# Access Compliance Report

## Public Rights-of-Way

### (Curb Ramps)

Intersection ID: 9748	Main Street: GLENWOOD_DR	Cross Street: HASHEM_DR	Location:	N
ADA ID: DCC58AC0798E	Ramp Type: Perp	Initial Pass/Fail: Fail	Overall Compliance: No	Severity Score: 21.25

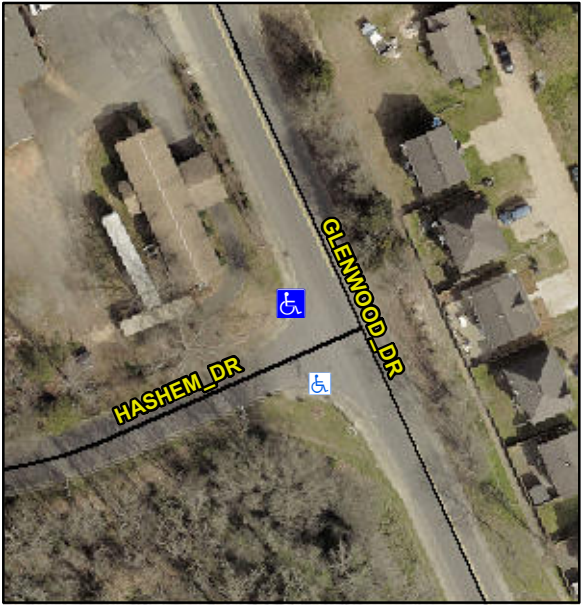
Codes/Mitigation Info/Possible Solution			Field Measurements/Component Compliance		
	Possible Solutions:		<b>Compliance</b>	<b>Description</b>	<b>Data</b>
	<b>Remove &amp; Replace Entire Ramp.</b>		<b>No</b>	Ramp Length (in)	60.0
			<b>No</b>	Ramp Width (in)	44.5
			<b>N/A</b>	Flare Type LT	N/A
			<b>N/A</b>	Flare Slope LT (%)	N/A
			<b>N/A</b>	Flare Traversable LT?	N/A
			<b>N/A</b>	Landing Length (in)	N/A
			<b>N/A</b>	Landing Width (in)	N/A
			<b>N/A</b>	Landing Slope (%)	N/A
			<b>N/A</b>	Landing X Slope (%)	N/A
<p>Surveyor Notes:</p> <p><b>N/A</b></p> <p>PROW/ADA:</p> <p><b>Not Found, R304.5.1, R304.2.2</b></p>			<b>N/A</b>	Flare Type RT	N/A
			<b>N/A</b>	Flare Slope RT (%)	N/A
			<b>N/A</b>	Flare Traversable RT?	N/A
			<b>N/A</b>	DWS Provided?	N/A
			<b>N/A</b>	DWS Contrast?	N/A
			<b>N/A</b>	DWS Length (in)	N/A
			<b>N/A</b>	DWS Full Width?	N/A
			<b>N/A</b>	DWS Offset (in)	N/A
			<b>N/A</b>	Shared Landing?	N/A

<b>N/A</b>	Gutter Ponding?	N/A
			<b>N/A</b>	Gutter Lip Ht (in)	N/A
			<b>N/A</b>	Painted X Walk1?	No
				X Walk 1 Direction	To S
			<b>N/A</b>	X Walk 1 Width (in)	N/A
				X Walk 1 Slope (%)	0.8
				X Walk 1 X Slope (%)	1.4
			<b>N/A</b>	Ramp inside XWalk1?	N/A
			<b>N/A</b>	Road Slope (%)	N/A
			<b>N/A</b>	Road X Slope (%)	N/A
			<b>N/A</b>	Any Obstructions?	N/A
Total Cost:		\$ 1850.00		Obstruction Type	
			<b>N/A</b>		
			<b>Yes</b>	Surface Condition? (G/P)	Good
